AUBURN HILLS 5TH ADDITION

Re: S/D97-84 -- Final Plat of AUBURN HILLS 5TH ADDITION

STAFF REPORT

CASE NUMBER: S/D 97-84 AUBURN HILLS 5TH ADDITION

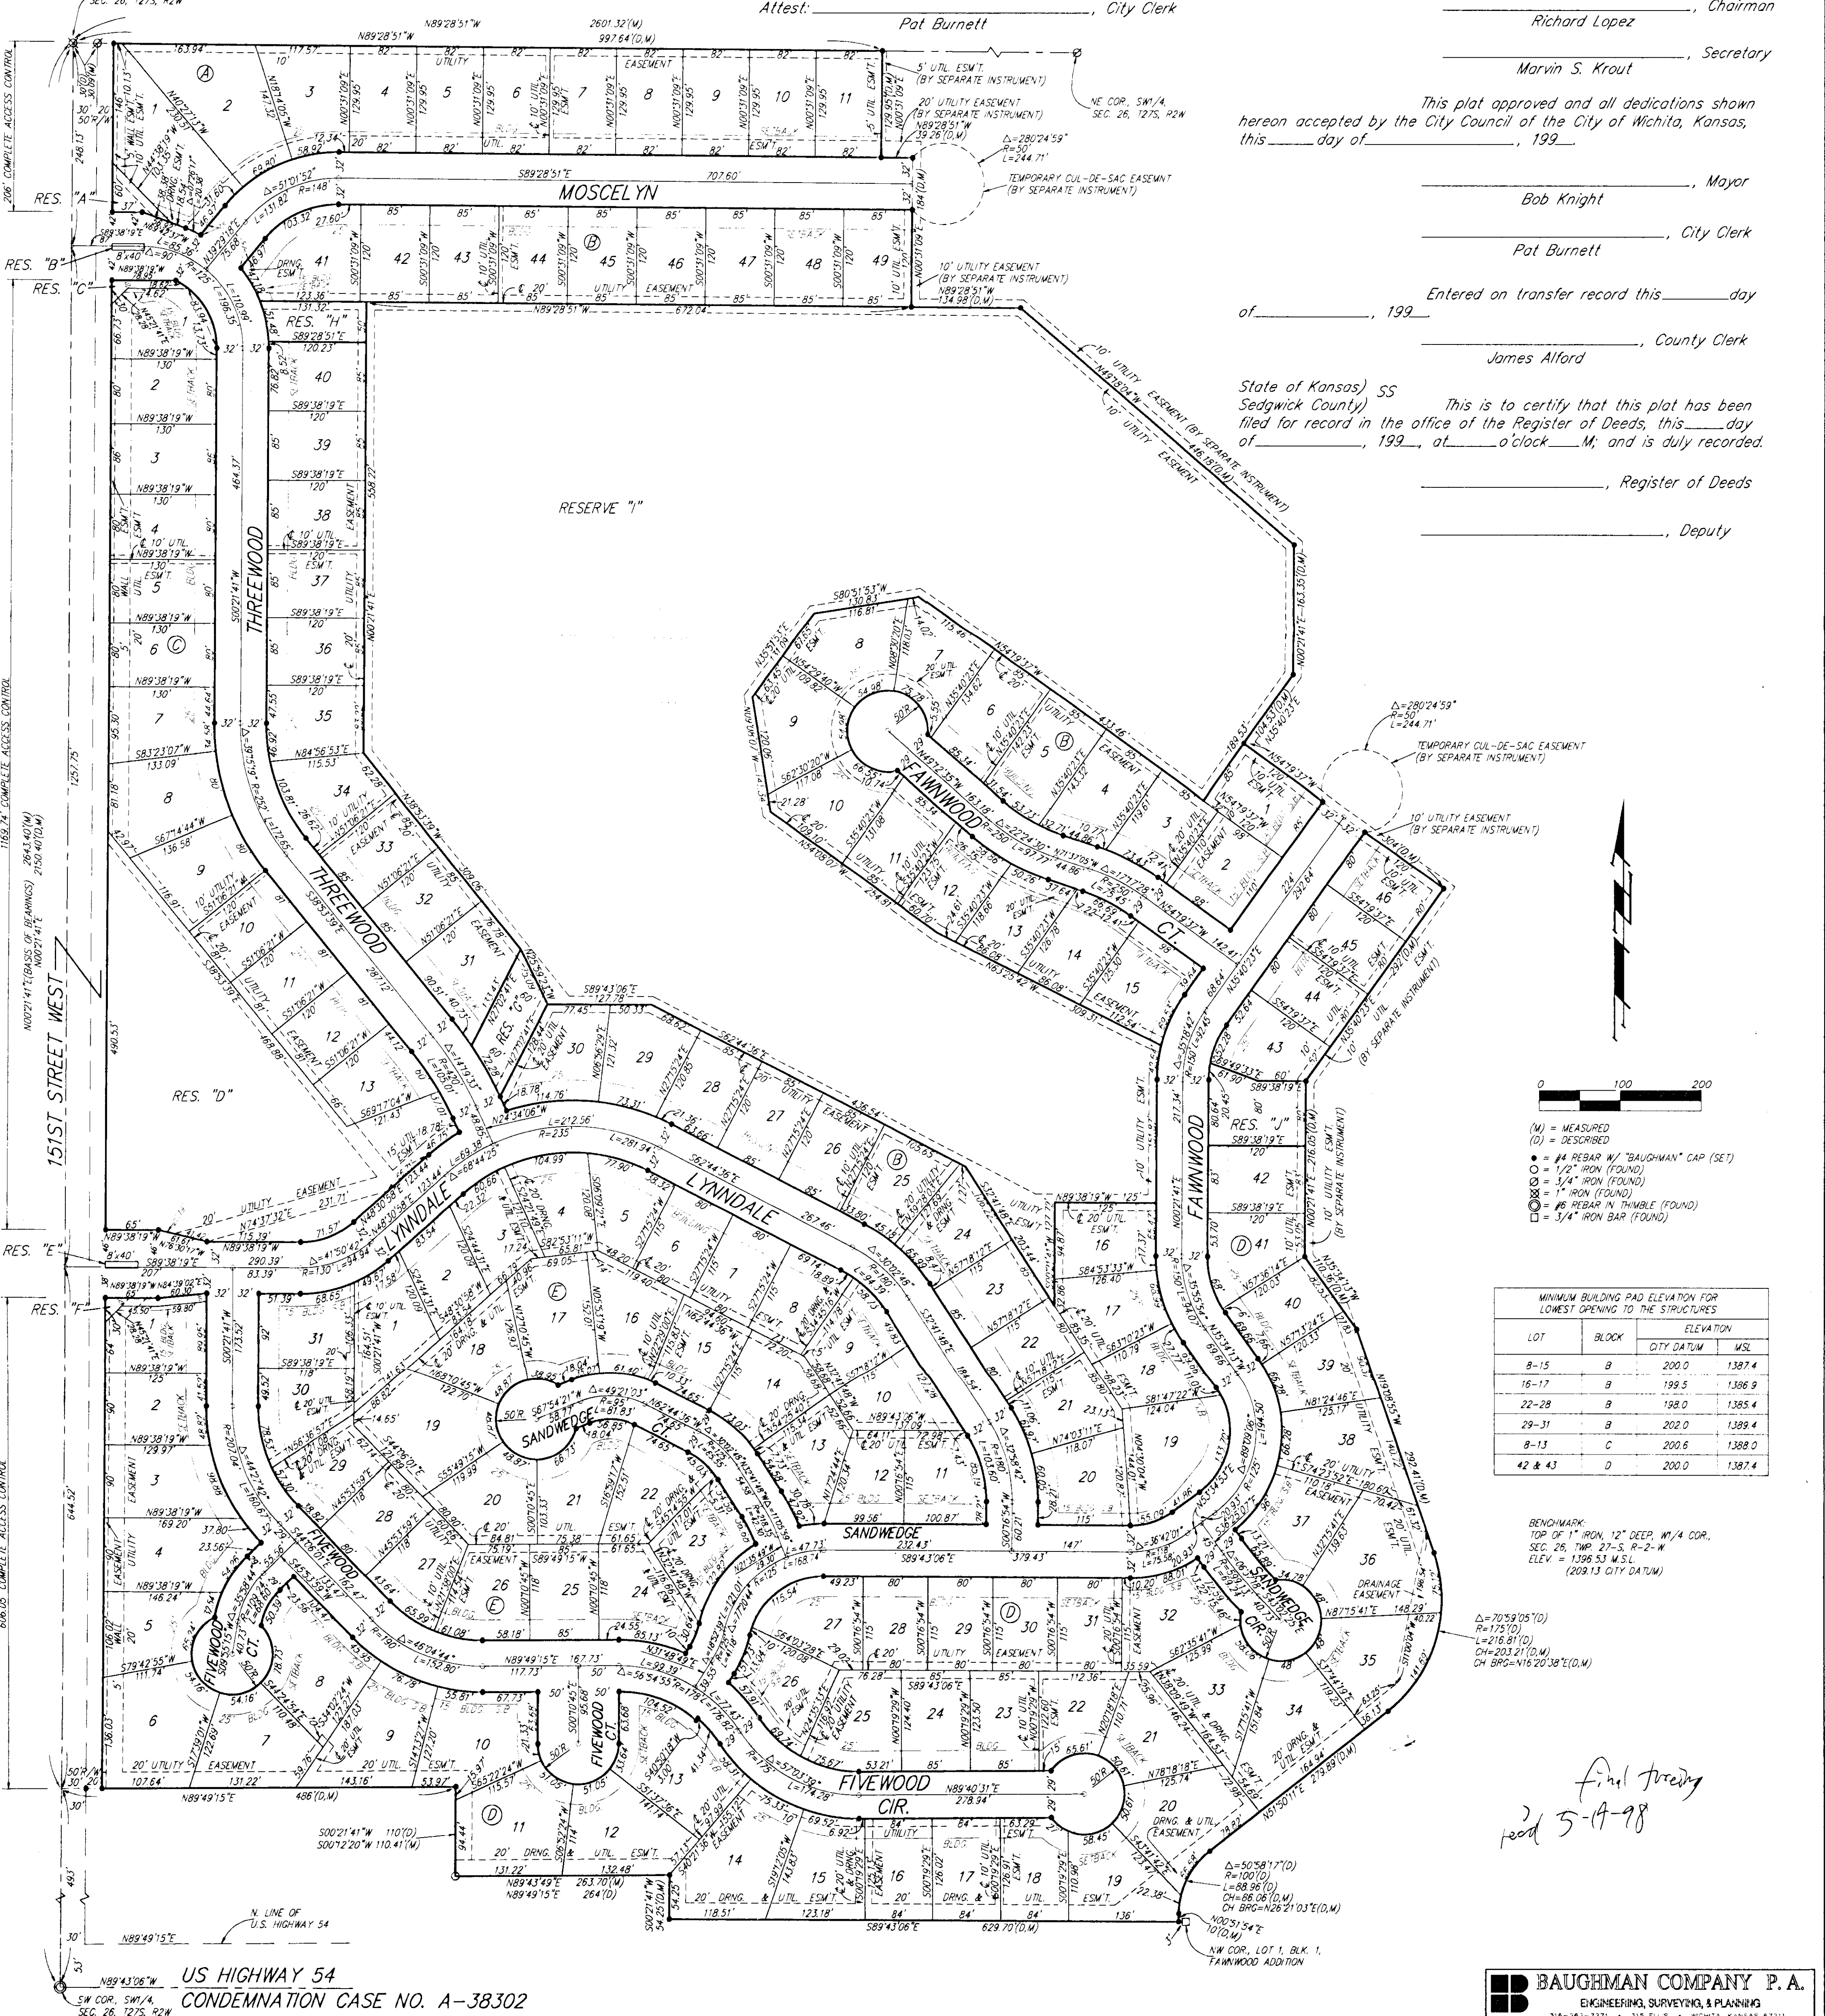
- E. A street stub to the north of this plat should be shown for connection to potential future development.

The final plat does not indicate the street stub to the north, as requested during preliminary plat review. However, the preliminary plat submitted for Auburn Hills 6th Addition indicates a street stub to the north adjoining the northeast corner of this plat.

- F. Distances should be shown for all segments of access control. On the final plat tracing, since the site will be within Wichita City limits upon annexation, the platlor's text shall note that the access controls are being dedicated to the "City of Wichita".

- I. The applicant needs to revise the legal description on the face of the plat to accurately portray the land being platted. The distances and degrees adjoining lots 11 and 12 on the southern line of the property need to be included in the platlor's text. In addition, several southern bearings on the face of the plat need to be corrected to reflect northern bearings as identified in the legal description.

- J. Temporary turnarounds will be needed for the terminus of Fawnwood and Onewood Streets. On the final plat, the area for temporary turnarounds should be shown with dashed lines around the area of the actual street.

The platlor's text should indicate that the temporary turnaround areas will automatically be vacated upon the extension of the streets.

The KG&E representative requested a 10-foot utility easement adjoining the right-of-way between Lots 15 and 16 in Block B which has not been denoted on the final plat.

KGE has requested additional easements as denoted on the attached plats.
